GJS Plot F, Manchester

Non-material Amendment | 23.08.2024

Z1-SHP-A180-RP-XX-NMA02 | P02

Consented Scheme - F1-SHP-G100-EL-XX-B5D801 - P01

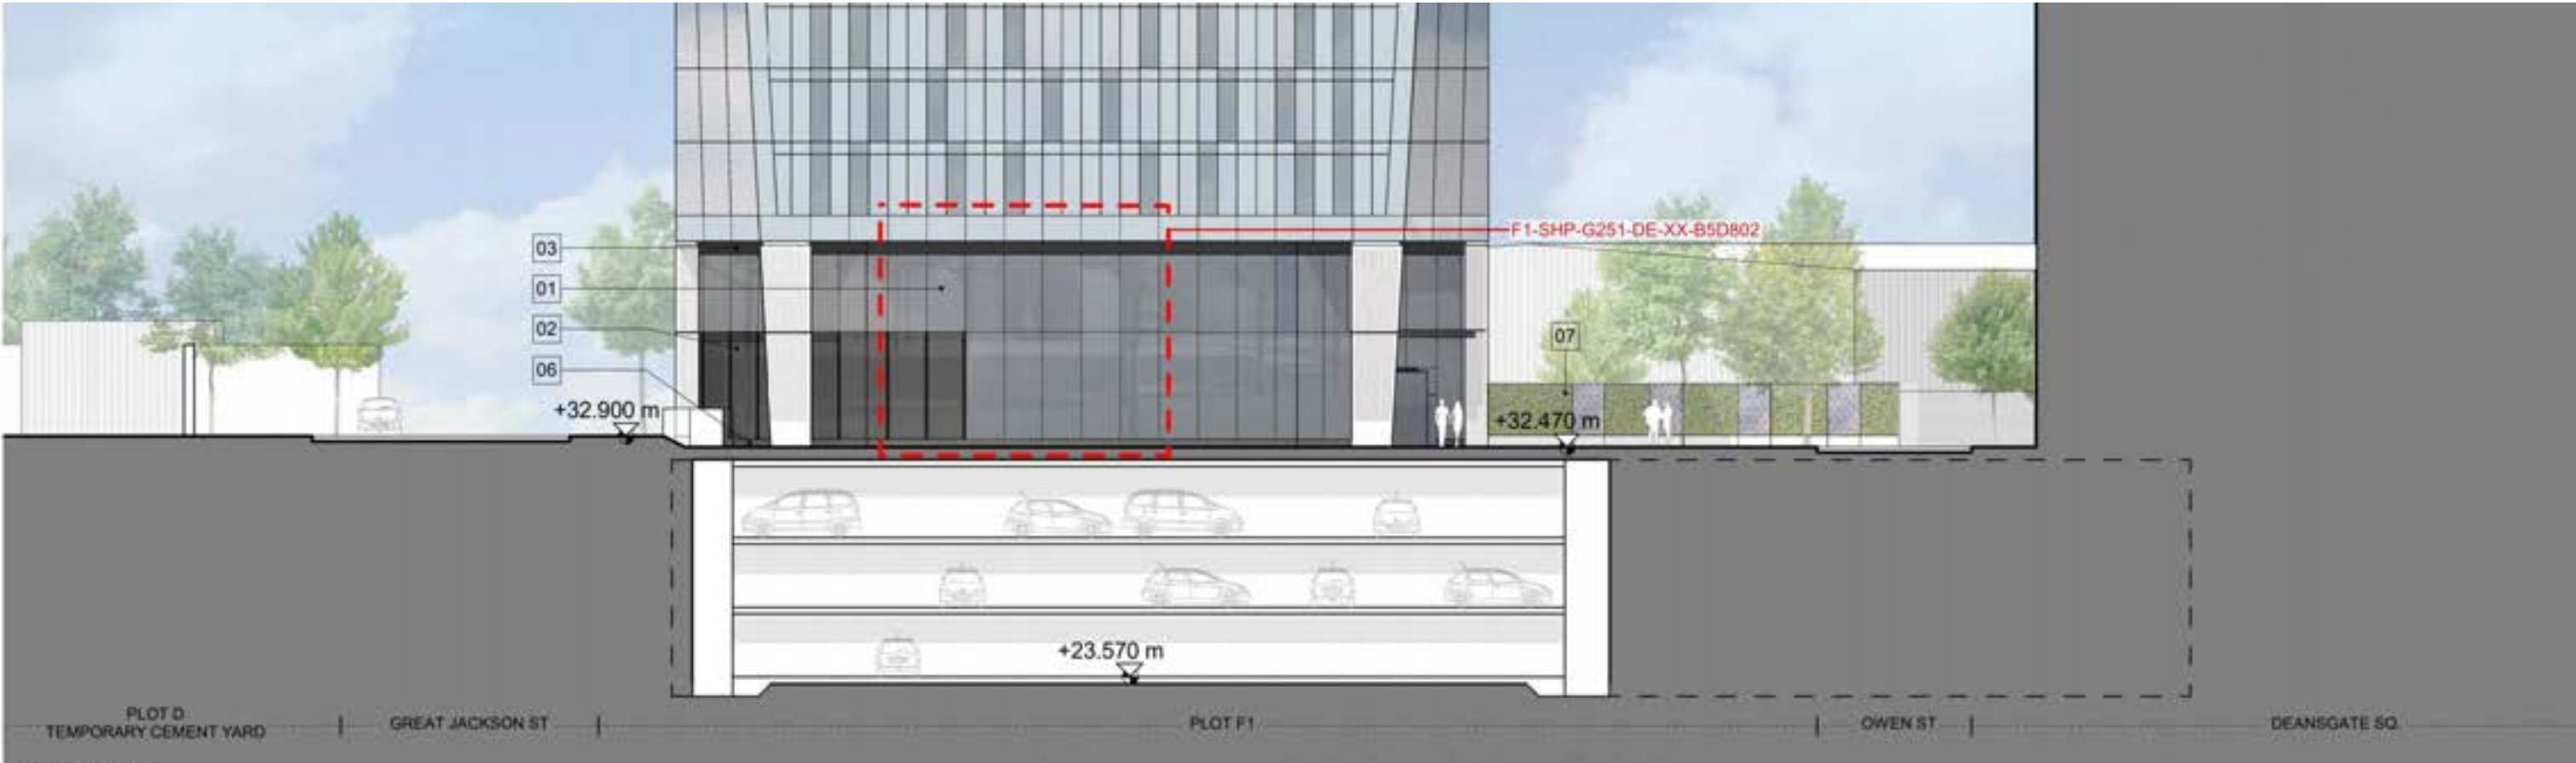
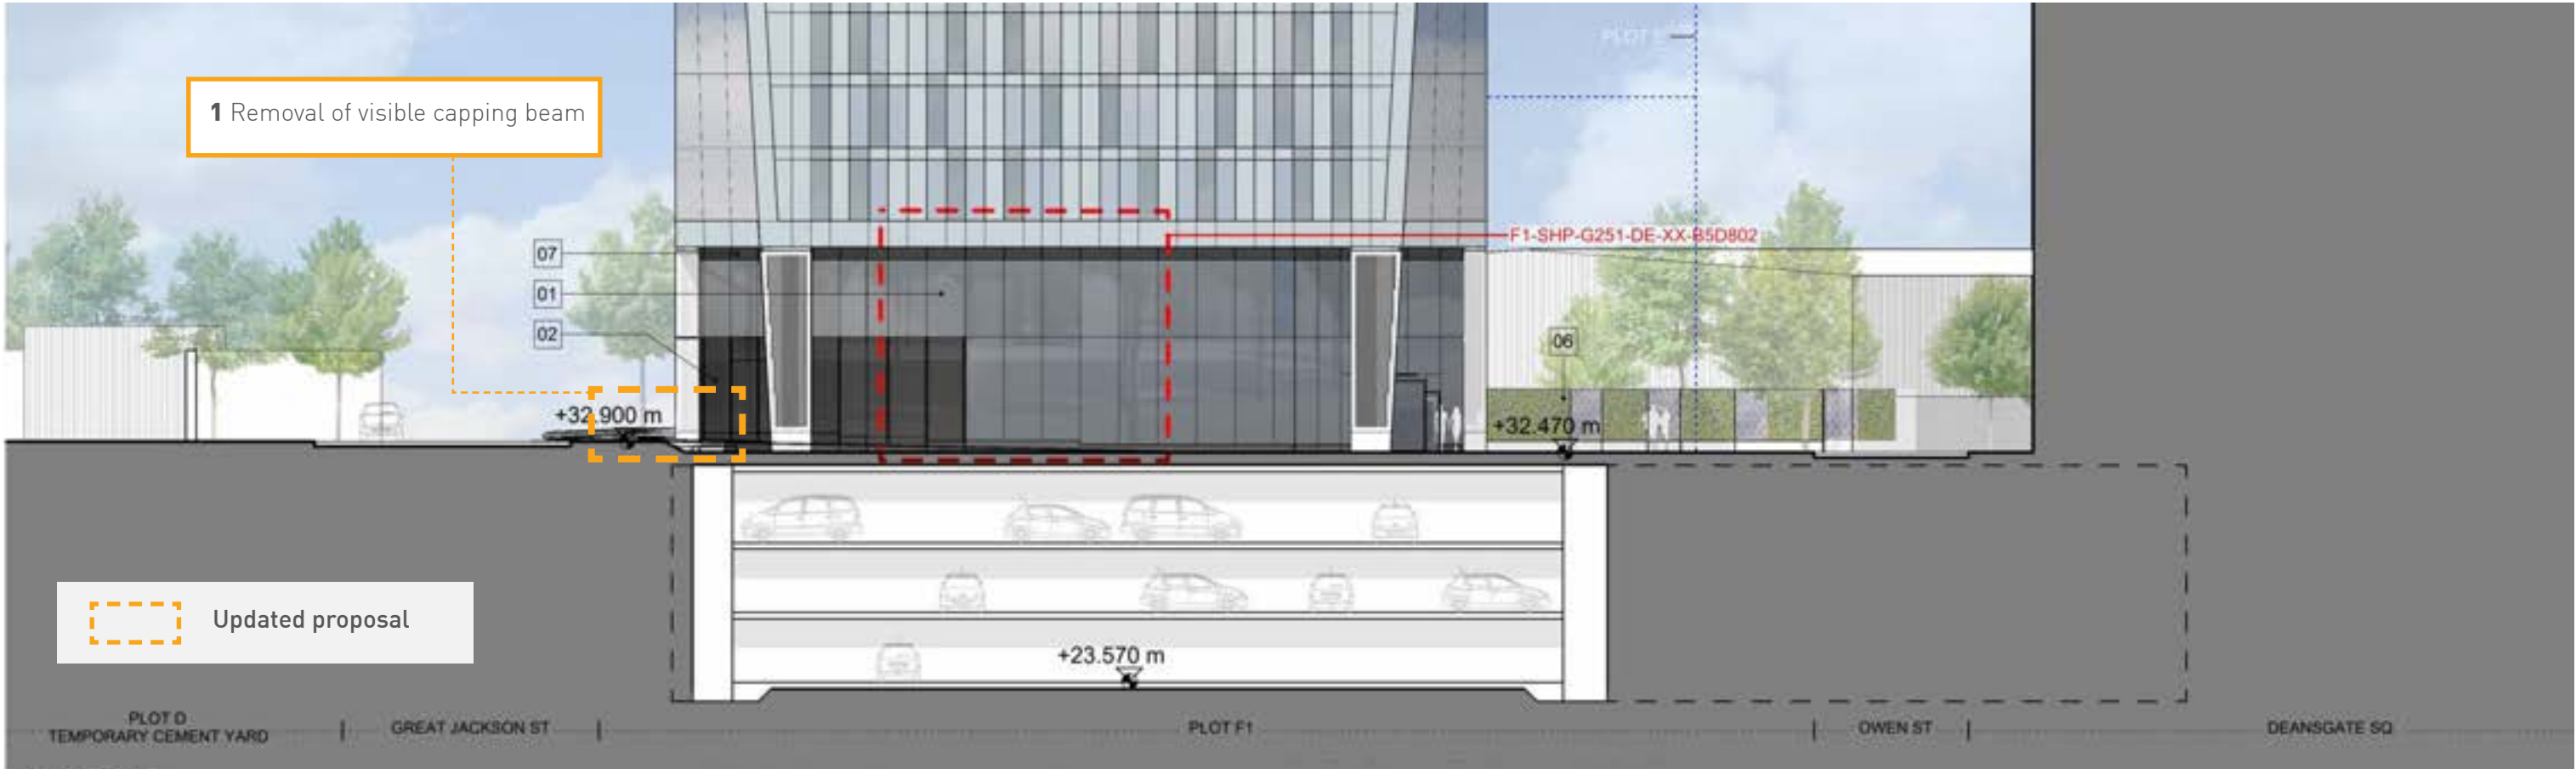
Tower F1 - Removal of visible capping beam along Great Jackson Street

At planning stage it was deemed necessary to keep the capping beam (top of the basement piled wall) above ground level, due to the proximity of the F1 capping beam to the pavement.

Through further structural design and refinement of temporary works, the design team have been able to lower the entirety of this structure so that it is not visible from street level, with the following benefits:

1 Removal of visible capping beam

Proposed changes - F2-SHP-G251-EL-XX-9001 - P05

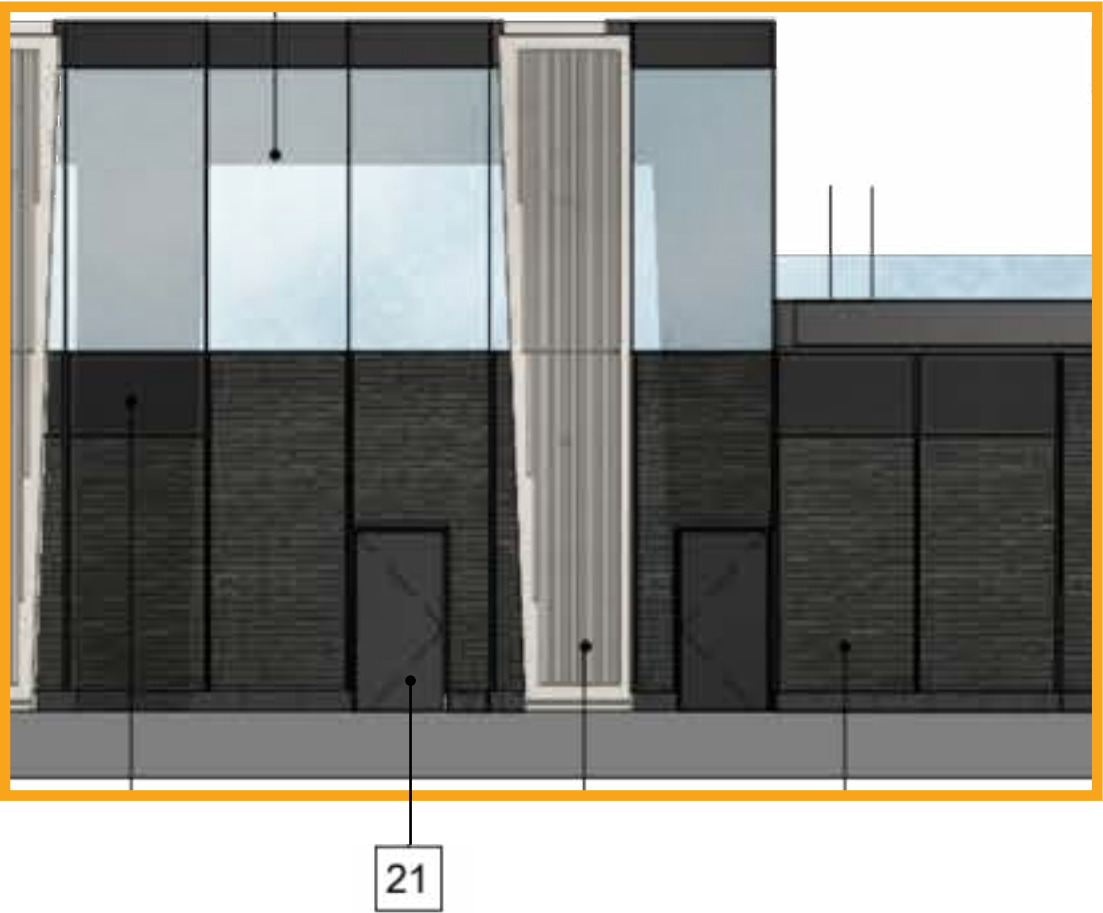
3c. Proposed amendment to doors:

Due to an increase in the required structural opening of the door to facilitate the required clear width for the escape doors. It is no longer feasible to have brick to the side of the door.

Instead a larger centralised door has been introduced, this will help to enforce the panelised language of the podium facade.
